MS24184L
AMENDMENT 1
2 June 1998

MILITARY SPECIFICATION SHEET

RELAYS, ELECTROMAGNETIC, 300 AMPERES, 1PST,
N.O. TYPE I, WITH AUXILIARY CONTACTS,
HERMETICALLY SEALED

This amendment is part of MS24184L, dated 4 March 1994, and is approved for use by all departments and agencies of the Department of Defense.

PAGE 2

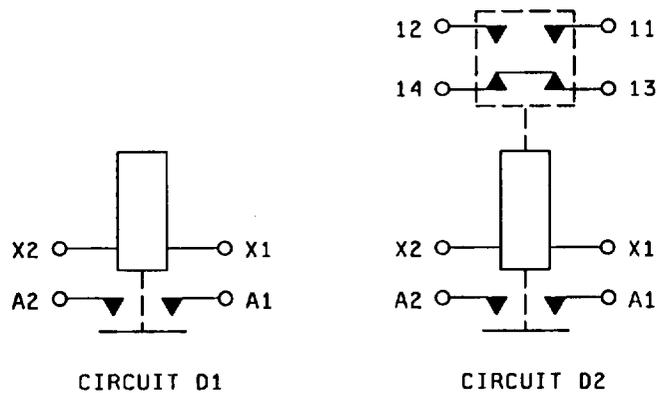
FIGURE 1, dimensions and configurations, delete CIRCUIT D1 and CIRCUIT D2 and substitute:
